**REQUEST TO ESTABLISH DOCKET**

4. Suggested Docket Title *Request for* Acknowledgement of abandonment of wastewater system in Putnam County by Weber Investments, Inc. and naming Putnam County as recycler.  
*lob*

Putnam County - Domestic Waste  
Port Buena Vista WWTF

WASTEWATER COMPLIANCE INSPECTION REPORT

overview of aeration basins

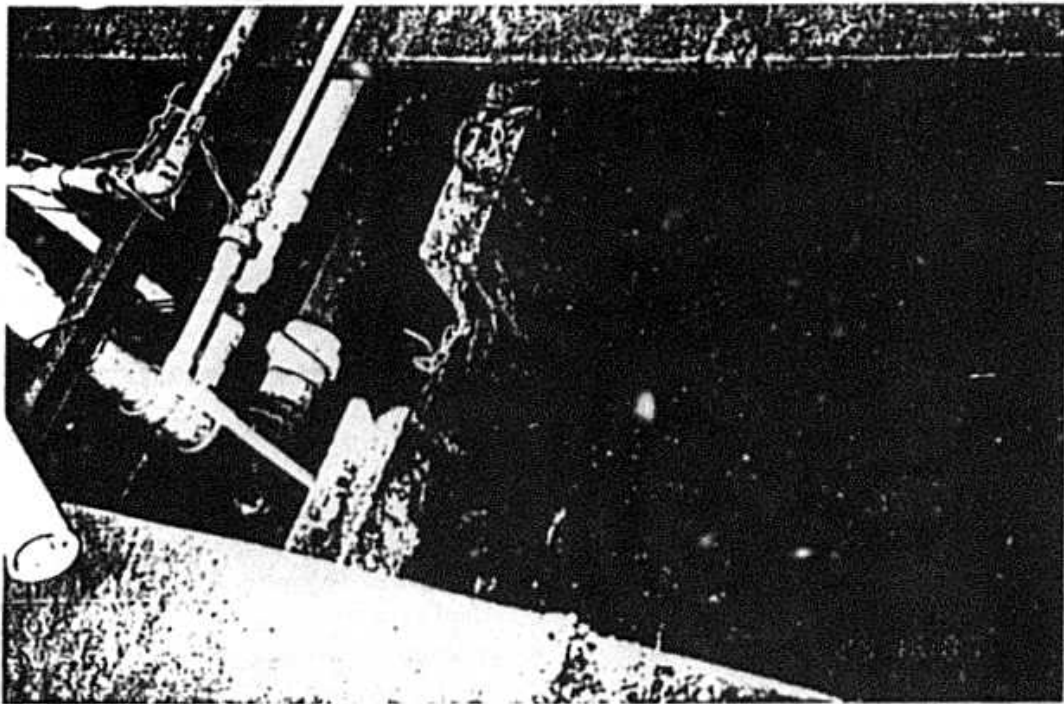
1. Aeration Tank - There was no air on at the time of the inspection. The contents of the tank appeared dark brown and covered with heavy foam. The timer for the blower indicated 1 hour off and 45 minutes on. The digester was overflowing into the aeration tank.

Chlorine Contact Chamber

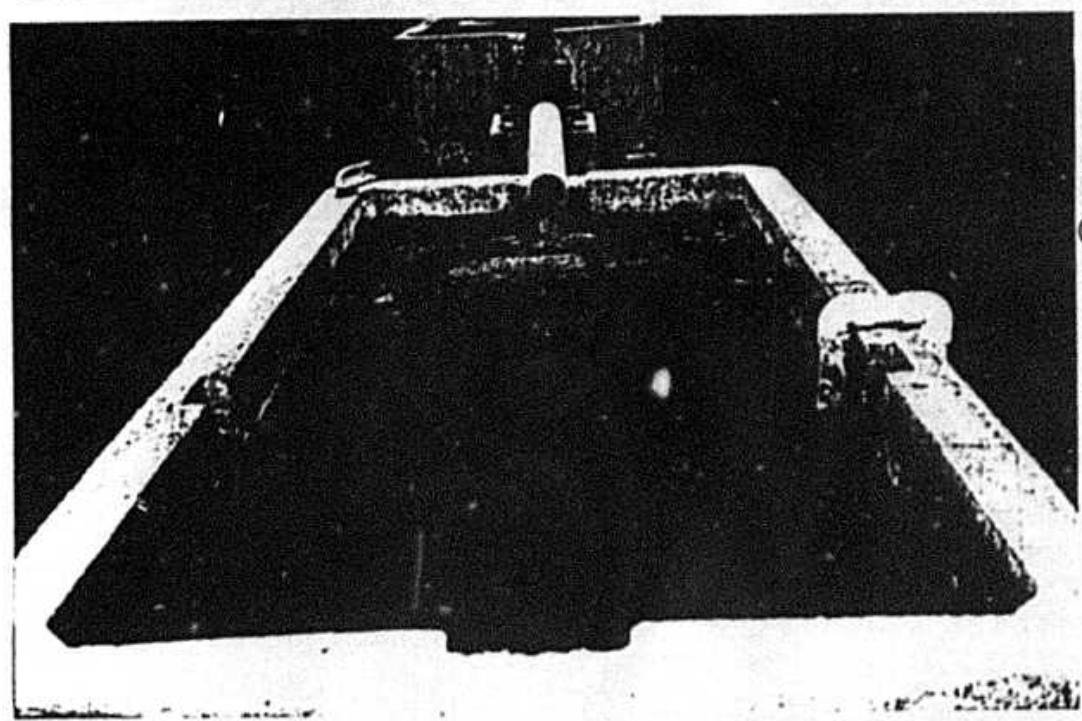
4. Chlorine Contact Chamber - Deep wet well, effluent is pumped (only one pump) to above ground baffled chamber. Chlorine residual is maintained by hypochlorinator which operates when the effluent pump comes on. The liquid chlorine tank was half full. The above ground chamber appears to have a layer of solids on the bottom. Effluent was slightly cloudy and bubbles were coming up from the bottom of the chamber. Chamber overfills to the point of overflowing when the pump is on. Chlorine residual was .91 mg/L.

Chlorine Contact Chamber  
evidence of overflows.

- c. Provide dechlorination tablets in order to maintain a total chlorine residual of 0.01 mg/l at the point of discharge.
  - d. Correct the intermittent overflowing of the new chlorine contact chamber.

overview of aeration basins

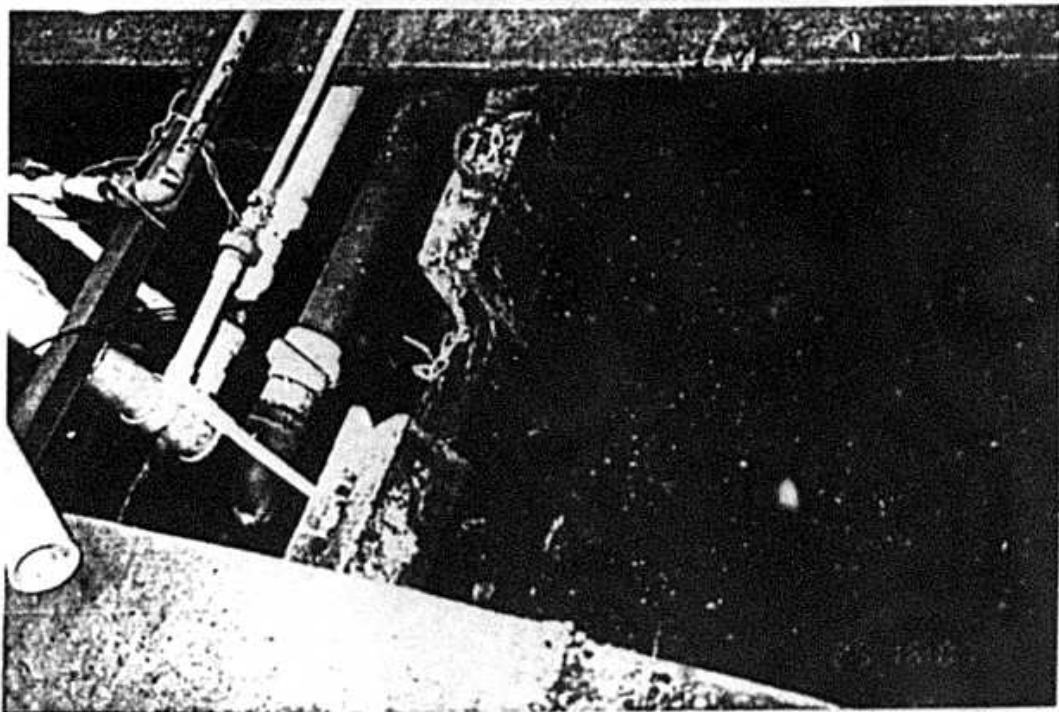
1. Aeration Tank - There was no air on at the time of the inspection. The contents of the tank appeared dark brown and covered with heavy foam. The timer for the blower indicated 1 hour off and 45 minutes on. The digester was overflowing into the aeration tank.

Clarifier working in 1st section.

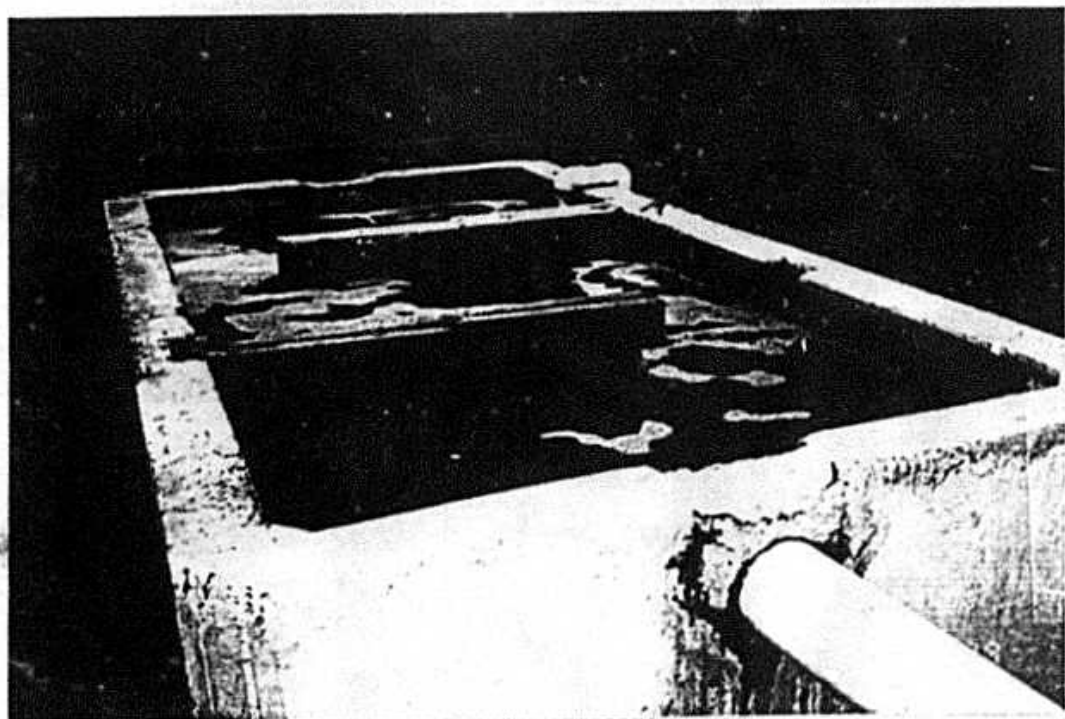
2. Stilling Area - This section had a thick covering of surface foam.
3. Clarifier - Split tank, 1st section of clarifier covered with surface scum, 2nd section appeared clear. The sludge blanket was not visible at the time of the inspection. The effluent was clear flowing over the weir.

Influent and digester overflow into 1st aeration basin. Note excessive foaming.

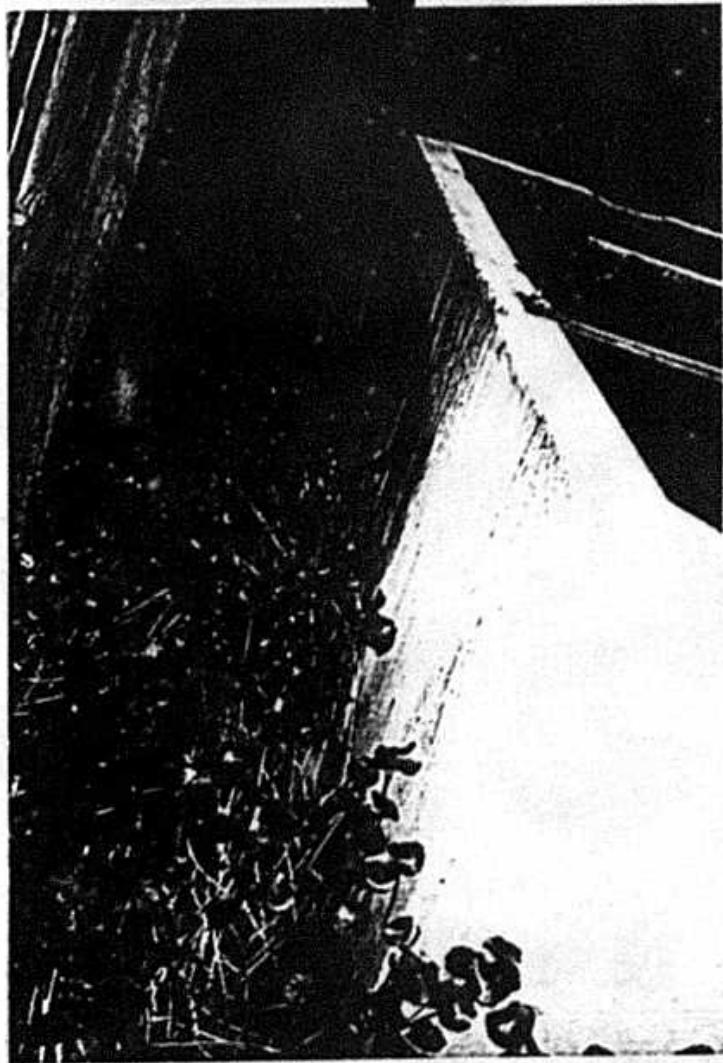
5. Digester - The digester was not being properly utilized. This tank was full and overflowing back into the aeration tank.
6. Effluent disposal - From the reaeration tank the effluent flow to a large holding pond which discharges into the St. Johns River. Pond is covered with hyacinths and other vegetative growth.

Thick foam in aeration basin.

- b. Signs are present which indicate the digester is not being pumped often enough. As noted in the past, the digester may need to be pumped as often as twice a month. Additionally, I recommend you connect a waste line to the first hopper of the clarifier.

Chlorine Contact Chamber  
evidence of overflows.

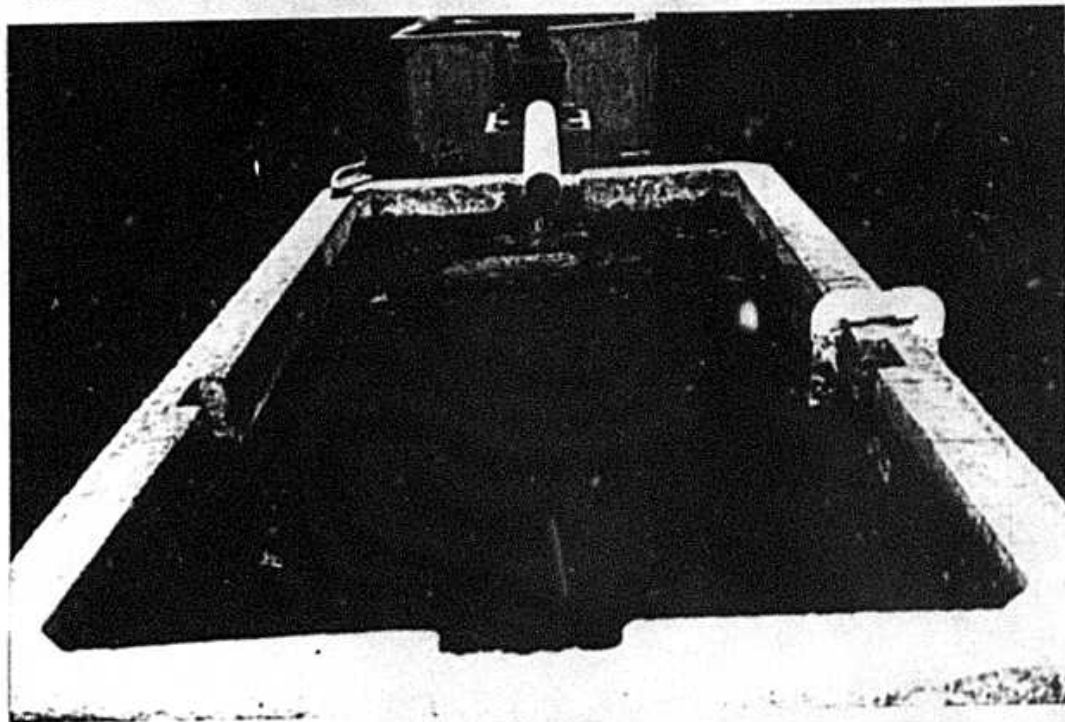
5. Dechlorination and reaeration tank - Effluent flows from Cl2.C.C. through a tablet box for dechlorination. No tablets in box at time of inspection. Clear effluent coming into and leaving tank. Air was not on at the time of the inspection. Tank bottom was not visible, possible solids build-up.

Dechlorination  
Reaction  
Chamber.

- e. Clean the solids from the chlorine contact chamber and the dechlorine chamber.
2. Comply with Specific Condition # 2 of Construction Permit DC54-253874 in accordance with Florida Statutes Section 403.161(b). A certification shall be submitted by a
